## ADDENDUM NO: 02

**DATE:** 01 April 2025  
**PROJECT NO:** 119.002  
**PROJECT:** Hyde Park Elementary School  
333 East 300 North  
Hyde Park, Utah 84318  
**OWNER:** Cache County School District  
Logan, Utah

N A Y L O R  
W E N T W O R T H  
L U N D  
A R C H I T E C T S

**E3**  
A101b  
ELECTRICAL CURB DETAIL  
1/12" = 1'-0"

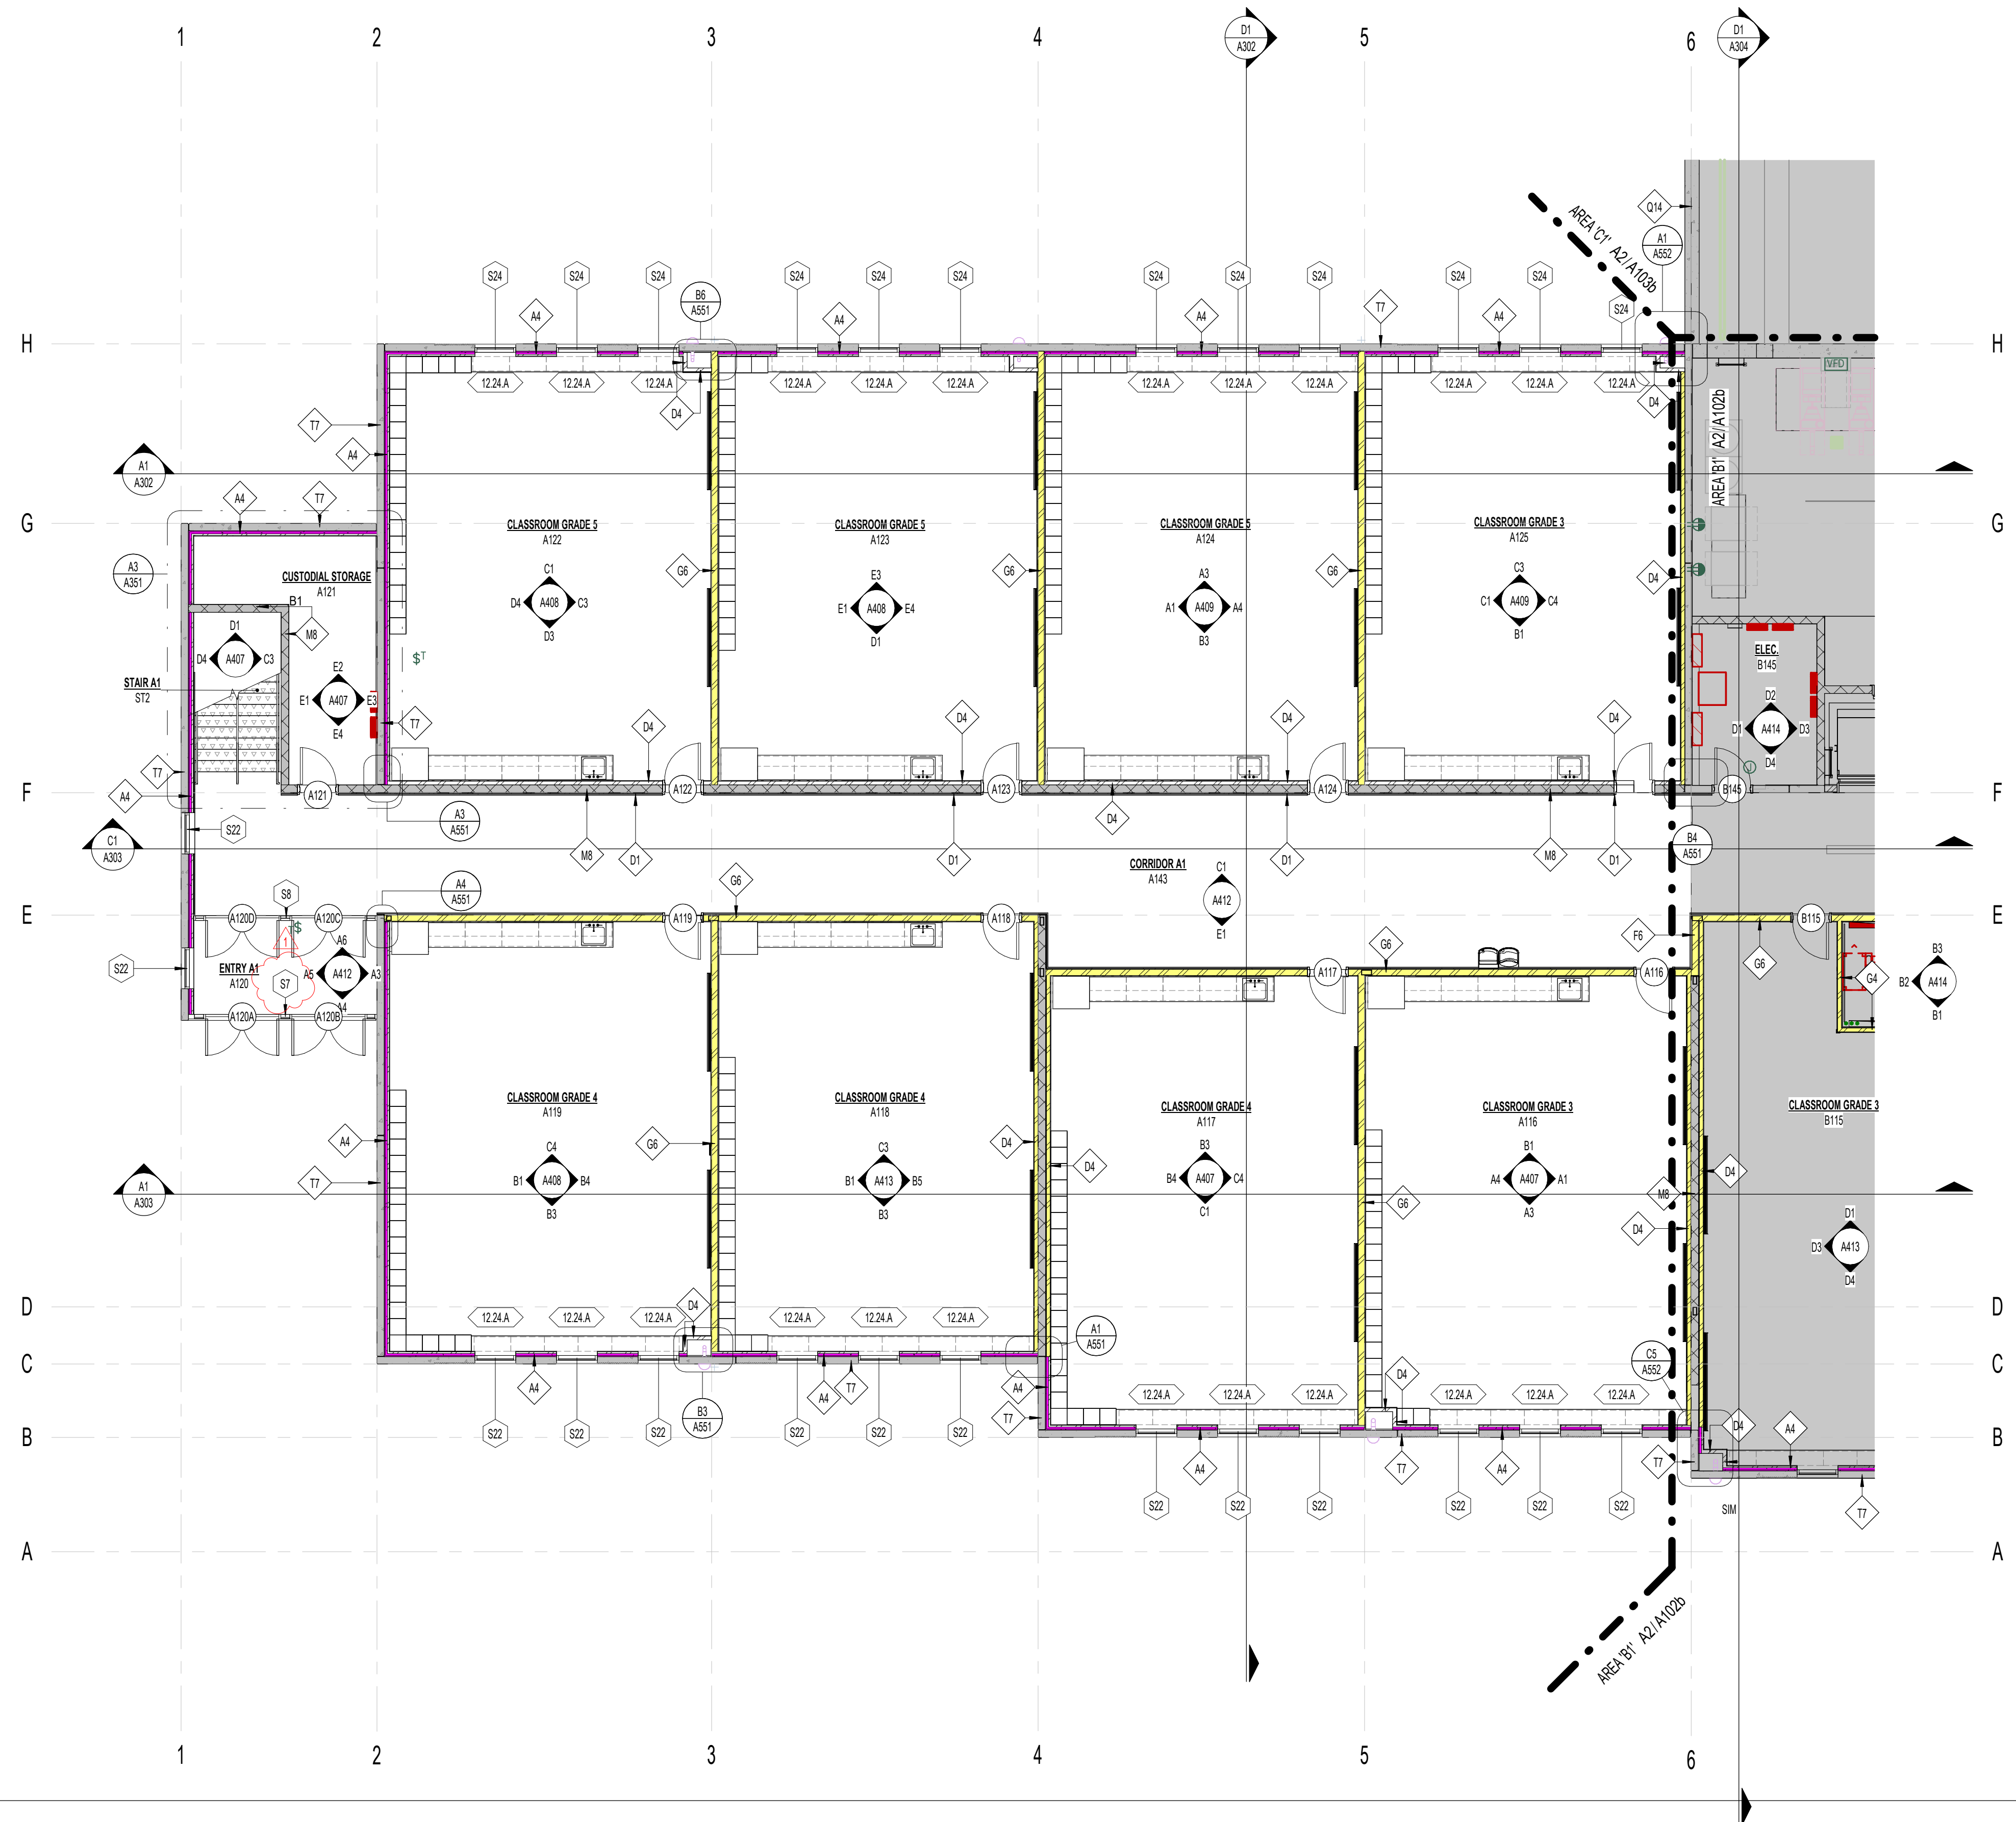
- Added storefront tag S7 at Entry A1 front door.
- General Notes # 6 adjusted to show correct detail number, E3/ A101b.
- General Notes # 10 adjusted to show the correct location of Mounting Heights schedule on interior elevation sheets.
- Corner Finish Symbol B1 adjusted to show correct detail number, E1/ A101b.
- Corner Finish Symbol B2 adjusted to show correct detail number, E2/ A101b.

1 A116 LEVEL 02 SLAB EDGE FLOOR PLAN 1/8" = 1'-0"

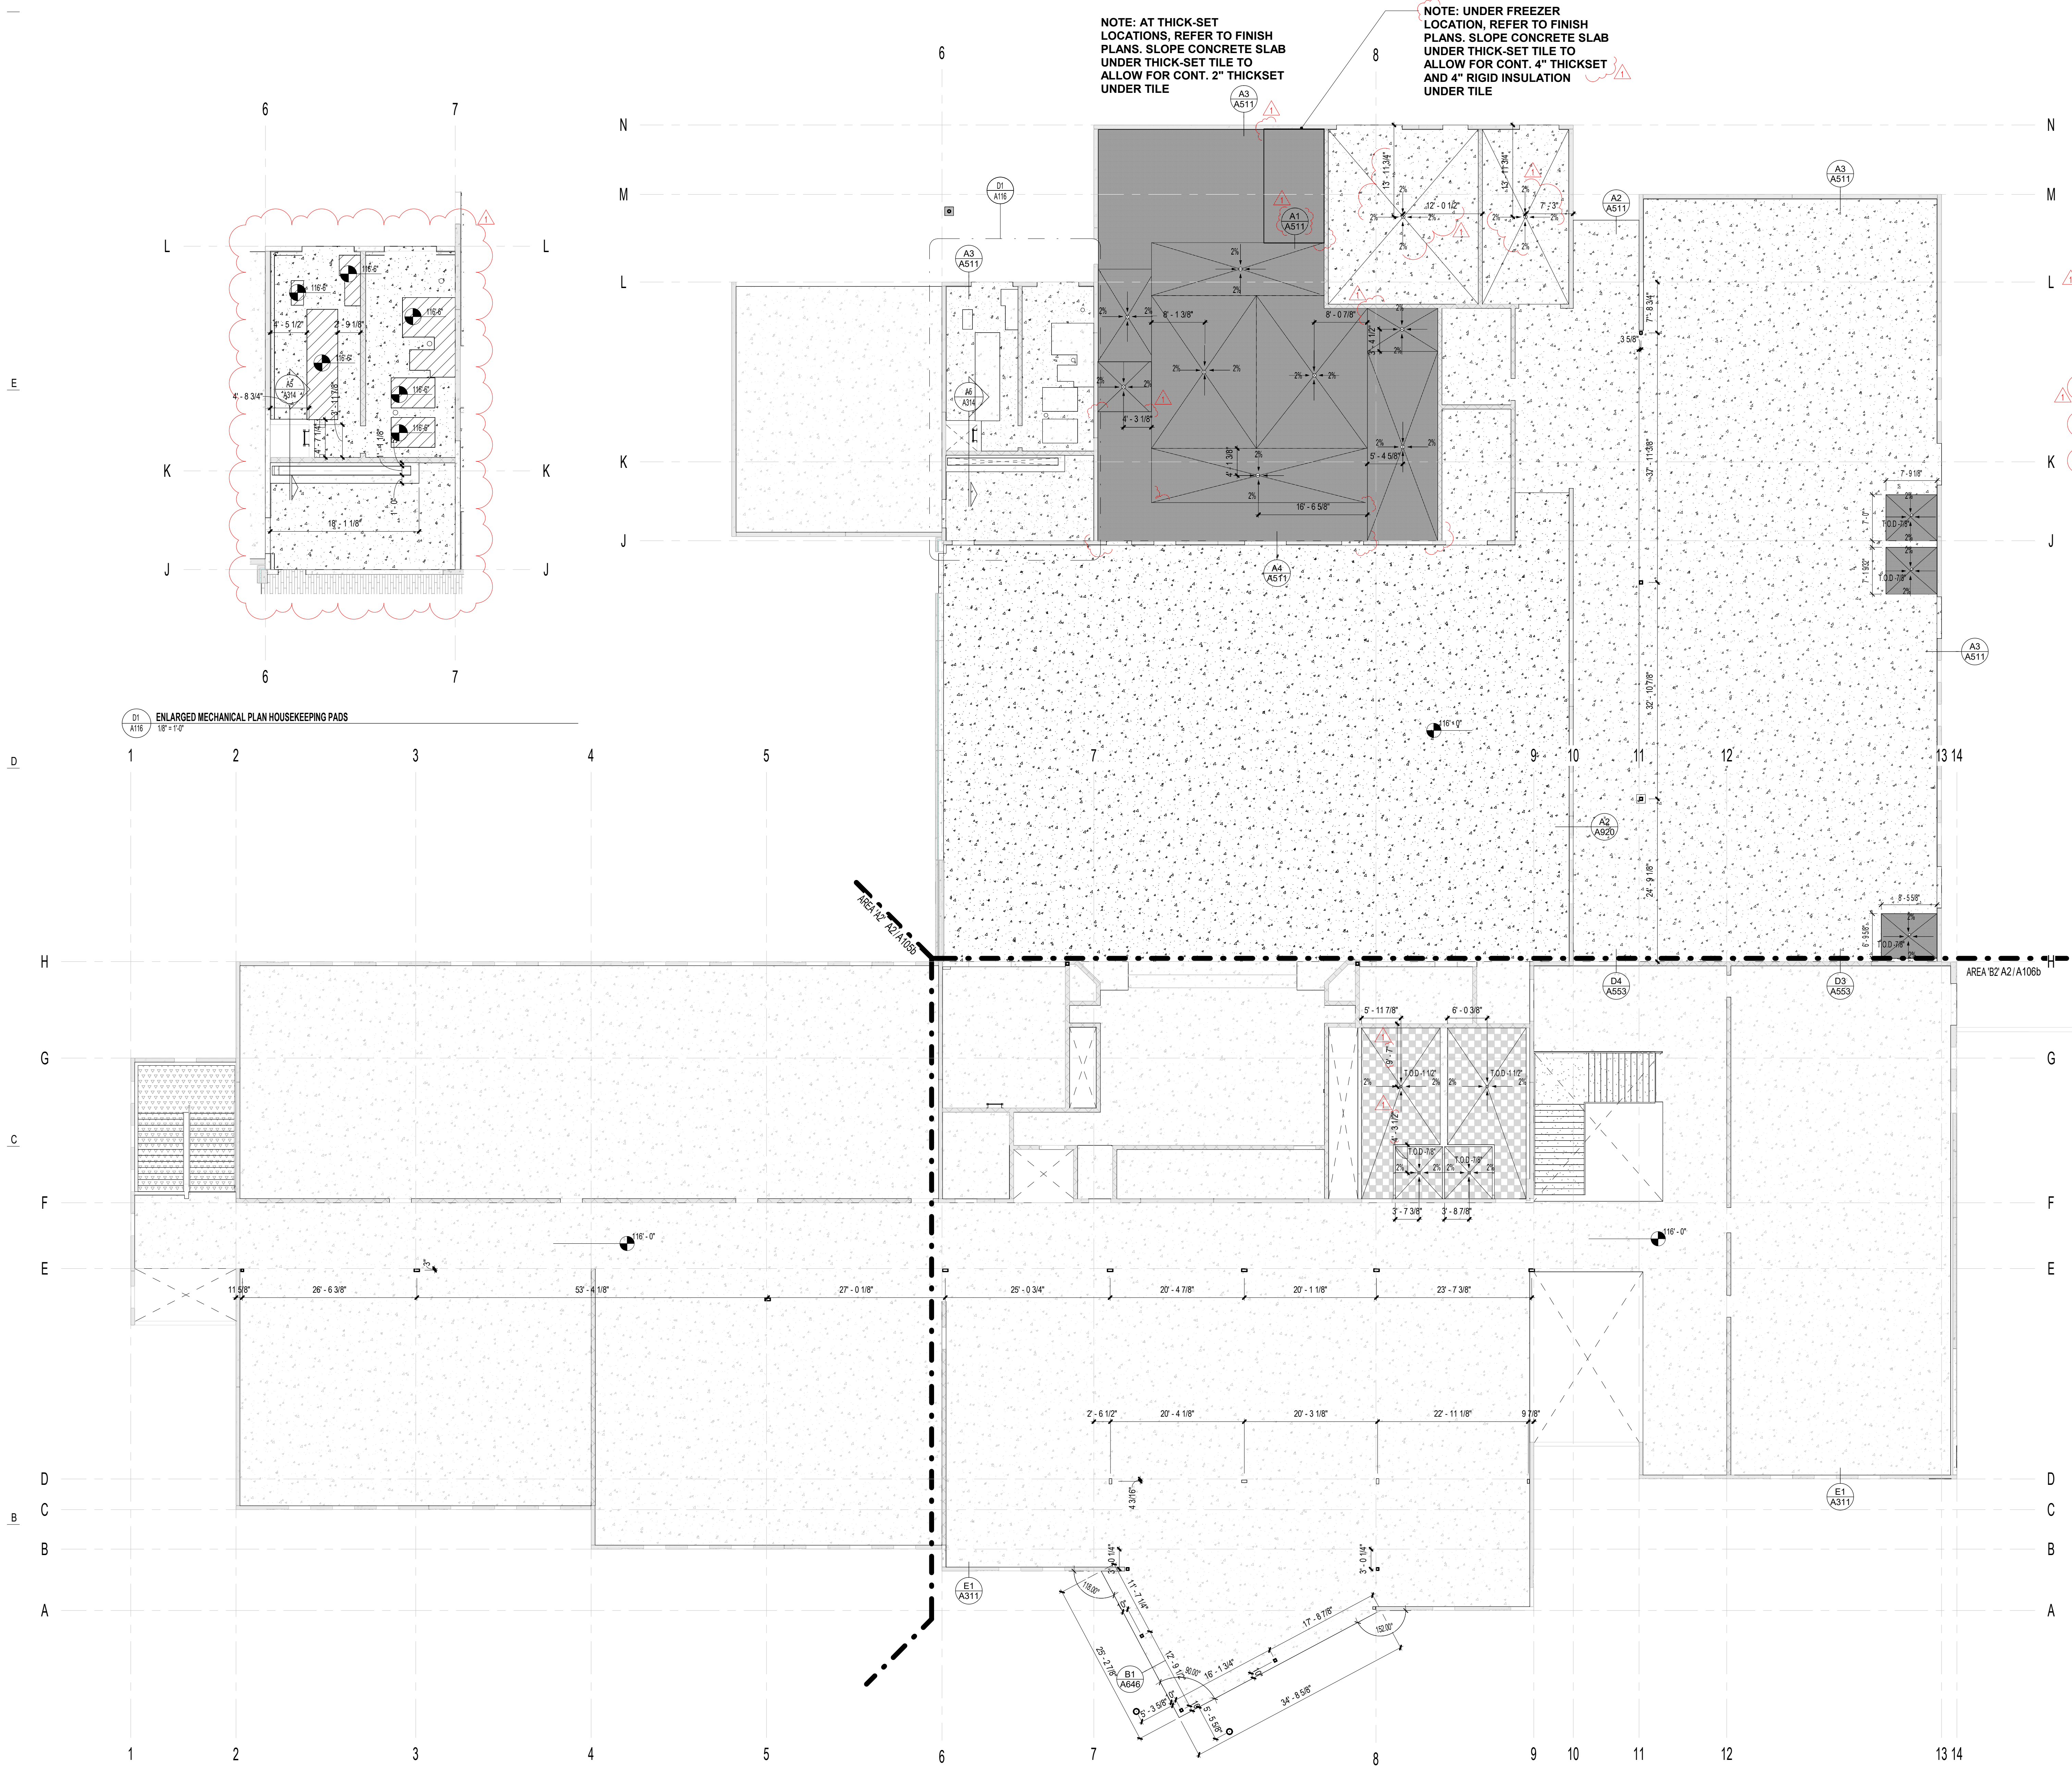
**Sheet A116 – LEVEL 02 SLAB EDGE PLAN**

- Added dimensions and slope to Exterior Storage and Receiving drains.
- Added dimensions to Restroom B221, B222, B223, and B224 drains for location clarity.
- Indicated area and added note for slab walk-in freezer.
- Tile pattern in C252 adjusted to correct fill pattern.
- Added detail Callout A1/A511.
- Included housekeeping pads in Area C mechanical rooms.
- Adjusted location of floor drains between housekeeping pads.
- Adjusted concrete and recessed concrete slab on grade or deck graphics in SLAB EDGE PLAN LEGEND.
- Extended quarry tile floor pattern in kitchen .
- Included detail D1/A116 - ENLARGED MECHANICAL PLAN HOUSEKEEPING PADS.
